TOWN OF PLAINFIELD BOARD OF ZONING APPEALS REPORT

DATE: December 15, 2025
CASE NO.: [BZA-25-080](#)
PETITIONER: Melissa Garrard, Pulte Homes of Indiana

REQUESTED ACTION: Variances of Development Standards

Section 7.5.A.1

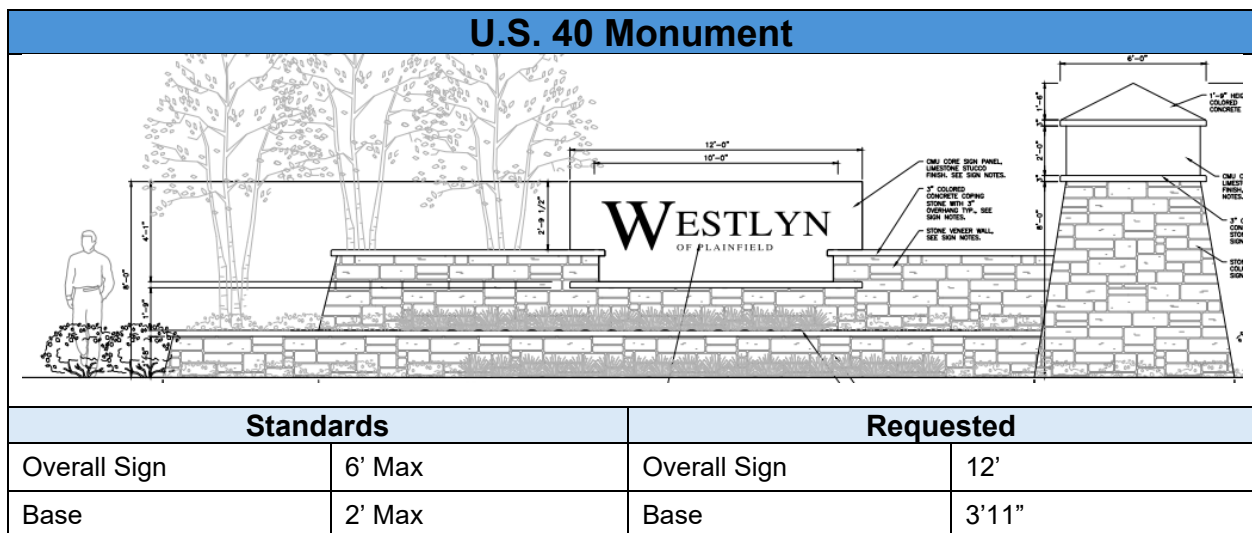
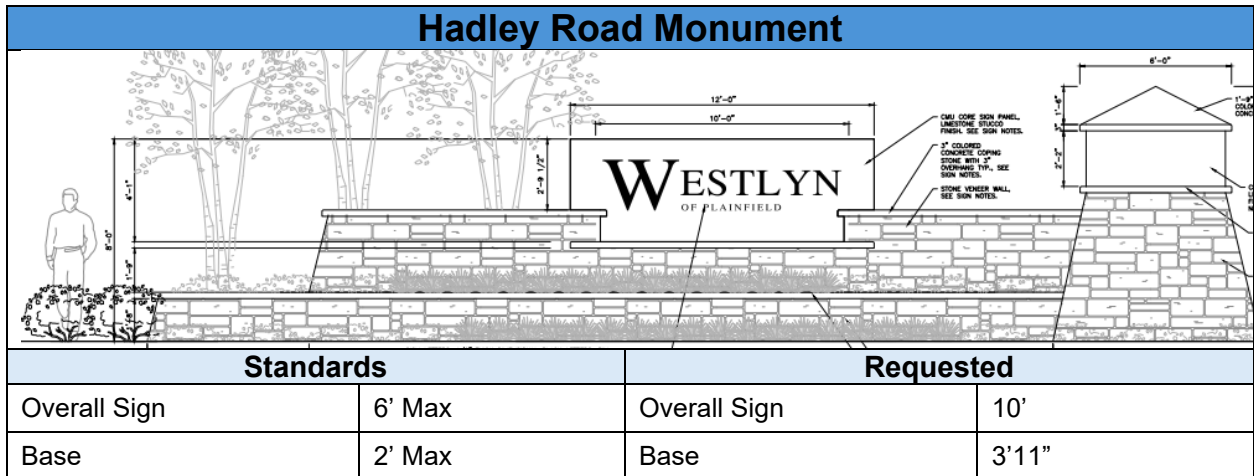
Sign Height. The height of a ground sign shall be measured from grade, which shall include the finished surface of the ground five (5) feet from the base of the sign, to the highest point of the sign. (See Example 7.5.A., in the PZO).

Figure 2 – Subdivision entrance monuments that are/are not permitted according to the Plainfield Zoning Ordinance

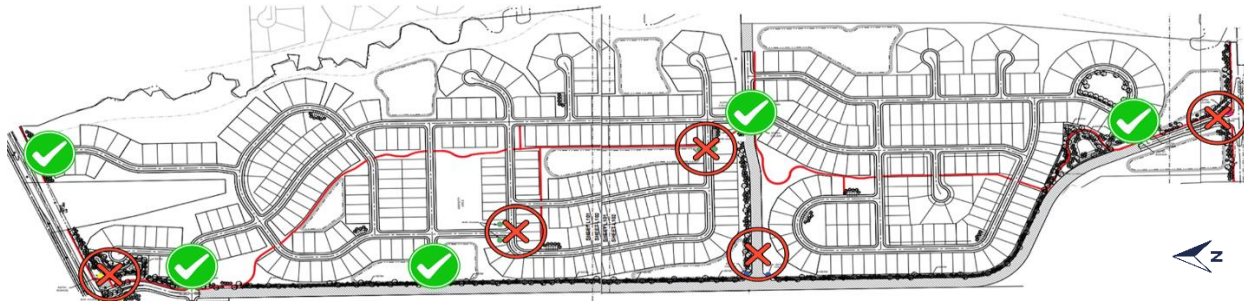
Figure 2, created by staff for the November BZA meeting, remains relevant for the applicant’s resubmittal. Red X’s show where requested signs would not be allowed under the PZO. Green check marks indicate permitted entrances of the proposed subdivision where signage / monumentation is allowed. Both green check marks and red X’s indicate where the applicant proposes putting signs, as shown in Figure 1.

Subdivision entrance signs are only permitted at the entrance of subdivisions. The intersections of the proposed north-south collector street at both U.S. 40 and Hadley Road are not subdivision entrances. Additionally, transitional points between one housing type to another housing type within the same subdivision do not qualify as subdivision entrances.

The proposed development will have six (6) formal entrances based on current town standards, one (1) along US 40, three (3) along the proposed north-south collector street, and one (1) on either side of the proposed east-west collector street (total of 2). Exhibit 2 above demonstrates where subdivision entrance monumentation would be allowed (green check mark) without request for variance. The red X’s indicate where requested monumentation would not be permitted under the PZO and would require a variance.
